URBAN DESIGN COMMITTEE

2. [Townhomes](#) at the northwest corner of 26th and U Street. – [UDR24052](#) – *Final Action*
3. Lincoln Youth Complex – Baseball and Softball Complex at N 1st St. and Cornhusker Hwy – *Preliminary Discussion*

URBAN DESIGN COMMITTEE STAFF REPORT

APPLICATION NUMBER	Urban Design Record #24052
APPLICATION TYPE	Advisory Review and Final Action
ADDRESS/LOCATION	NW Corner 26 th and U Streets
HEARING DATE	April 02, 2024
ADDITIONAL MEETINGS	--
APPLICANT	Aaron Burd, amburd76@gmail.com
STAFF CONTACT	Arvind Gopalakrishnan, 402-441-6361, agopalakrishnan@lincoln.ne.gov

TYPICAL FRONT ELEVATION

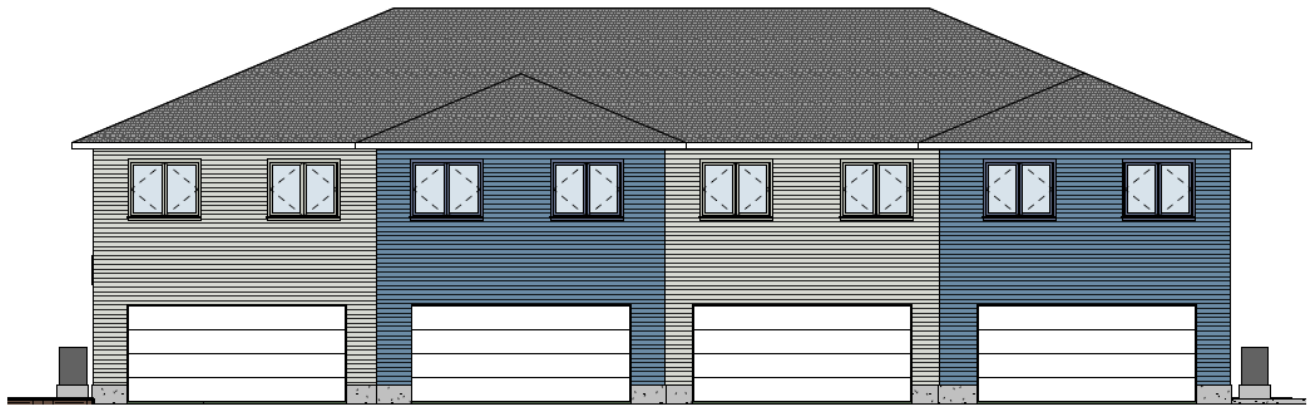
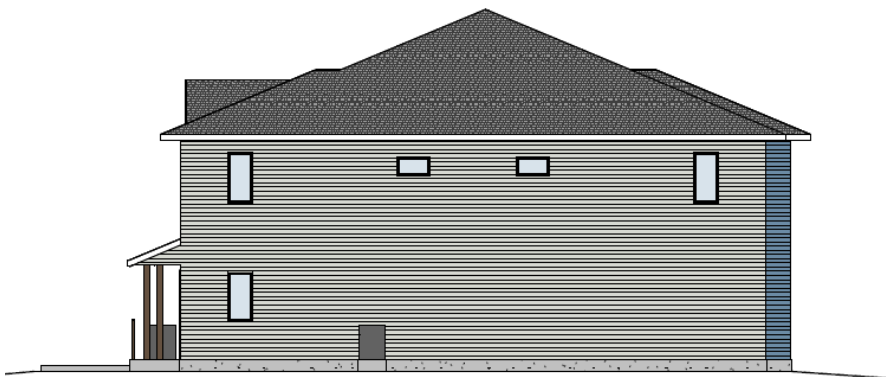
- It would be good if it could look less new and a bit more integrated into the neighborhood. Internal grills would be nice, and though it may not be necessary or code because of the short elevation of grade, would be to still have some railings up front on the porches.

- Members like to see housing going in but would like to see more dimension on the exterior façade. It would be good to do a one-over-one double-hung window or add dimension to the window or main elevations such as a porch rail to match the neighborhood. The style of railing isn't as critical as the presence of a railing. It helps to break up the flatness and neutralness of the façade and gives a nod to architectural styles in the neighborhood.
However, the porch is 5' wide and adding a railing would considerably reduce the usable space. It can be used as a stoop without railing. In staff's opinion, the plants around the porch will add to the aesthetic and hence, might not require railings.

- A member asked if the window casing could be differentiated color-wise, to differentiate it from the siding color. In the design, the trims are the same color as the siding, and the windows would be white.
Currently, most houses in the block and district feature trims either in white or contrasting colors with the siding. Staff suggests standardizing all trims to white, or contrasting colors. This adjustment will enhance depth in the facade and make the siding colors stand out more effectively.

- A member stated that even though 8-inch siding is more available he would like to see it narrower, and the applicant stated it's more cost-effective to have the 8-inch siding.

- The member then stated to try to keep it constant with what is more ubiquitous in the neighborhood. It takes more time and money, but he would like to see a narrower reveal.

- A member stated there are cost considerations and there can be a happy medium. Changing the siding would be preferable, but changing the windows and railings may be more cost-effective. The point is to not make it look old but to bring in some of those elements of the neighborhood.

- A member stated the typical side elevations have major view potential, especially on 26th Street and those look bleak. Worth stated to get better window patterns on those facades as well. Otherwise, they are relatively blank and don't contribute much to the neighborhood.
The applicant stated one side is the garage and they cannot have windows due to LES guidelines since they are next to transformers. They had designed more windows originally but had to remove them.

Worth stated the typical side elevations have major view potential, especially on 26th Street and those look pretty bleak. Worth stated to get better window patterns on those facades as well. Otherwise, they are relatively blank and don't contribute much to the neighborhood

Burd stated one side is the garage and they can't have windows due to LES guidelines since they are next to transformers. They had designed more windows originally but had to remove them.

ATTACHMENT D- ELEVATIONS

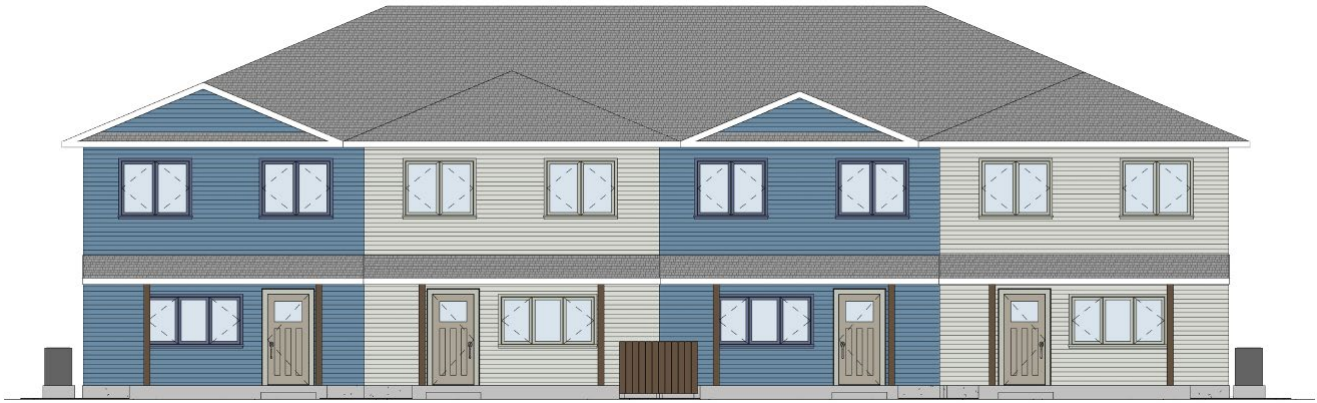
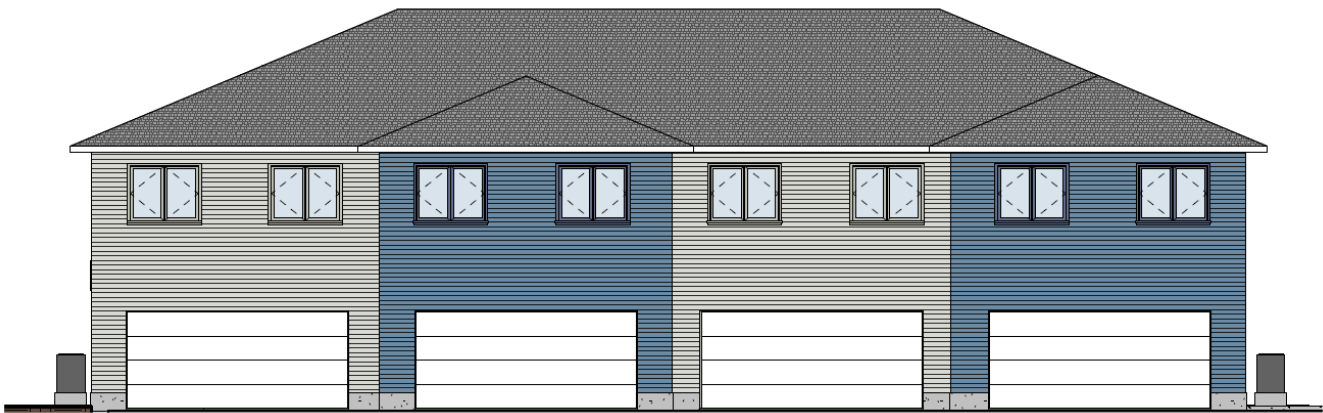
McCown stated he would like it to look less new and a bit more integrated into the neighborhood. Internal grills would be nice, and though it may not be necessary or code because of the short elevation of grade, would be to still have some railings up front on the porches.

Gengler stated she likes to see housing going in but wants to see more dimension on the exterior façade. It would be good to do a one-over-one or add dimension to the window or main elevations such as a porch rail to match the neighborhood. The style of railing isn't as critical as the presence of a railing. It helps to break up the flatness and neutralness of the façade and gives a nod to architectural styles in the neighborhood.

Newport asked if the window casing could be differentiated color-wise. Something to differentiate it from the siding color.

McCown stated that even though 8-inch siding is more available he would like to see it narrower.

McCown stated to try to keep it constant with what is more ubiquitous in the neighborhood. It takes more time and money, but he would like to see a narrower reveal.

Burd stated it's more cost-effective to have the 8-inch siding.
